**Re Proposed Draft Plan of Subdivision, Draft Plan of Condominium, Zoning By-law Amendment and Site Plan Application  
Villa Lago Residence Inc (c/o Treasure Hill Homes)  
9023 5 Sideroad, Part Lot 5, Concession 7 (ALB)  
File Numbers: 21T-16003C; CDM-16002C, RZ 16-06, SPA 16-042**

**Re: Architectural Control/ Urban Design Peer Review  
Proposed Site Plan Approval Application  
Villalago Residences Inc.  
9023 5<sup>th</sup> Sideroad (Part of Lot 5 and Part of the Road Allowance between West  
Halves of Lots 5 and 6, Concession 7 and Blocks 118, 152 – 154, 165, 167, 178,  
181 and 182), Registered Plan 43M-1251 (Albion)  
Town File No: 21T-16003C, CDM-16002C, RZ-16-06, SPA 16-042  
Our Ref No.: W-2026**

BLOCK 4  
FOUNDATION & FIRST  
FLOOR PLANS

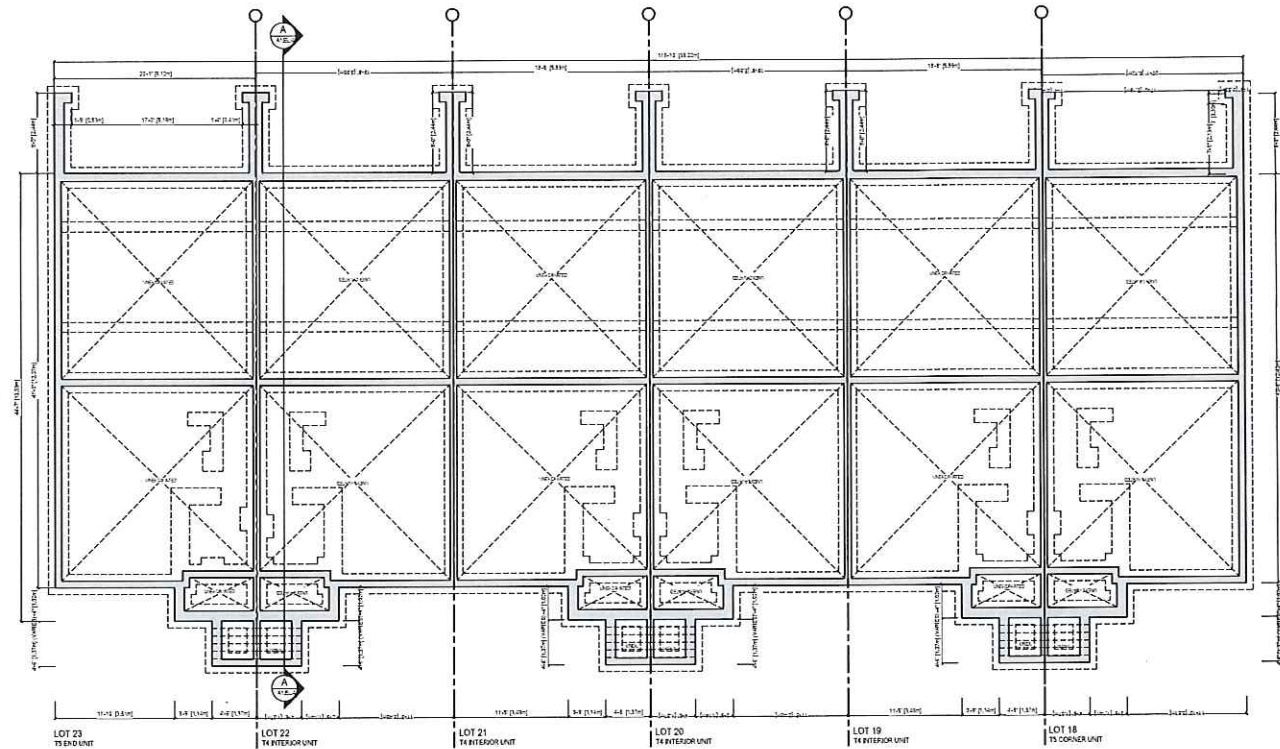
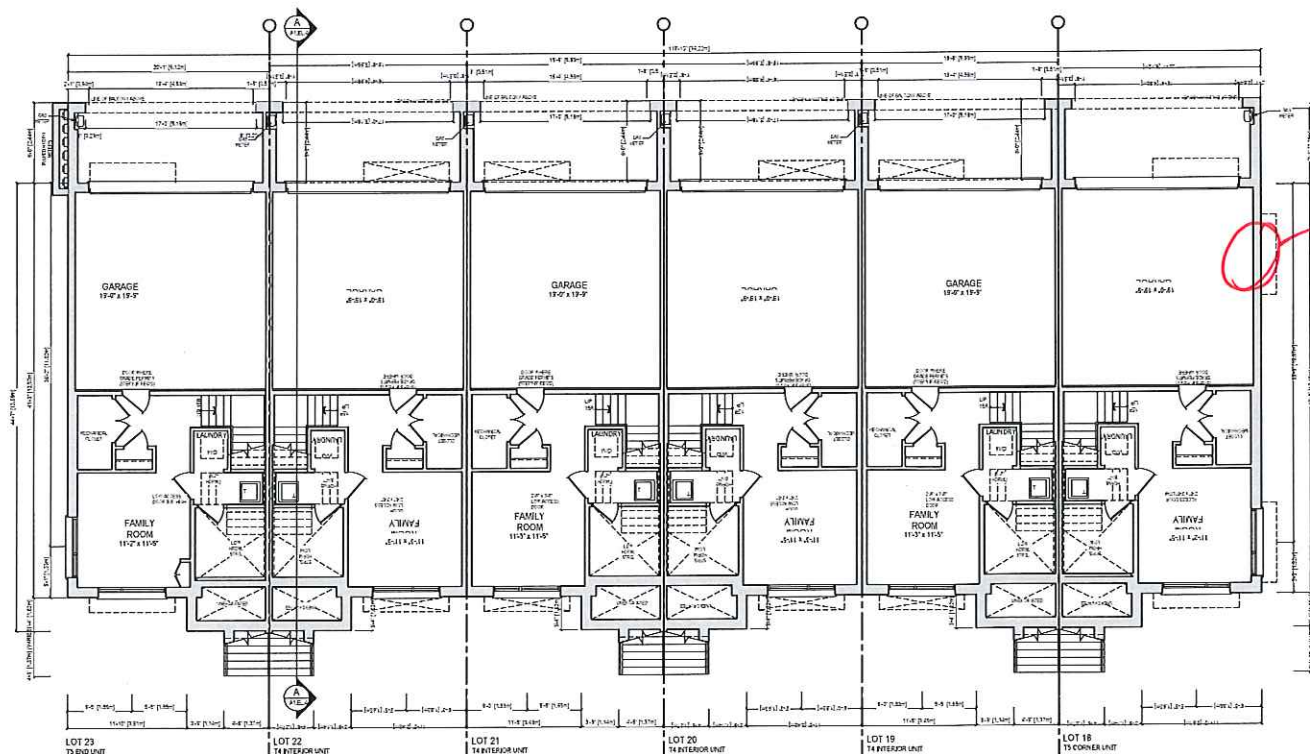
ADD WINDOWS  
to garage  
(corner unit)

LOCATE AIR CONDITIONING  
UNITS ON REAR DECKS  
AWAY FROM PUBLIC VIEW (TYP.)

EAST ELEVATION  
(RIGHT SIDE)

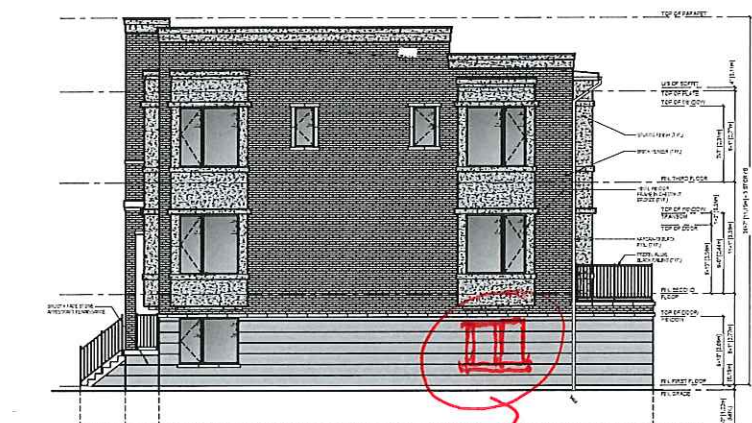
Add window to garage for corner units

SOUTH ELEVATION  
(FRONT)

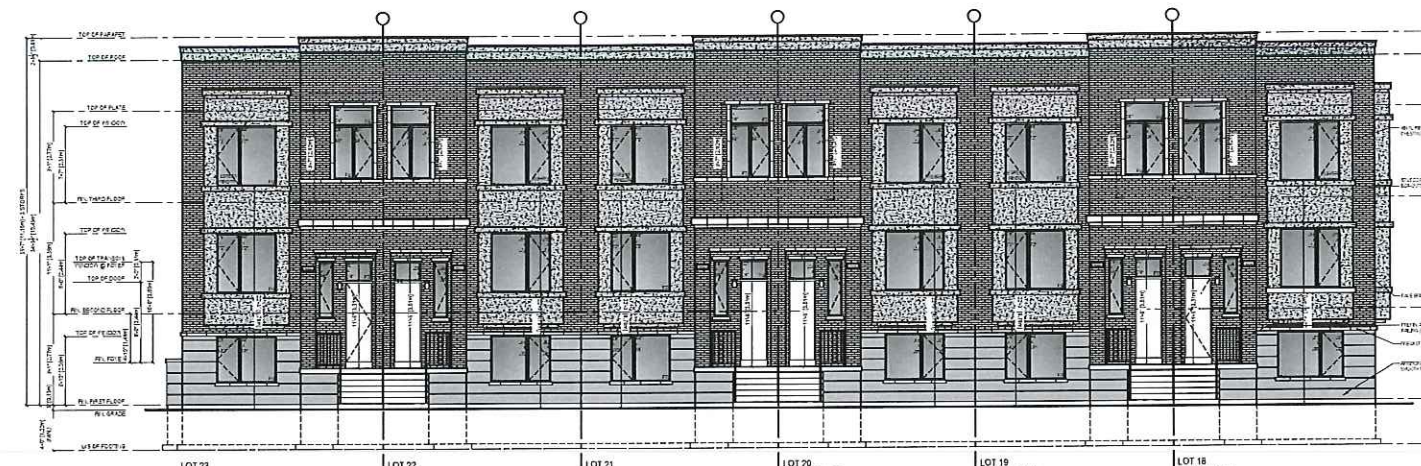
Provide garage door glazing due to interface w/ front loaded units.
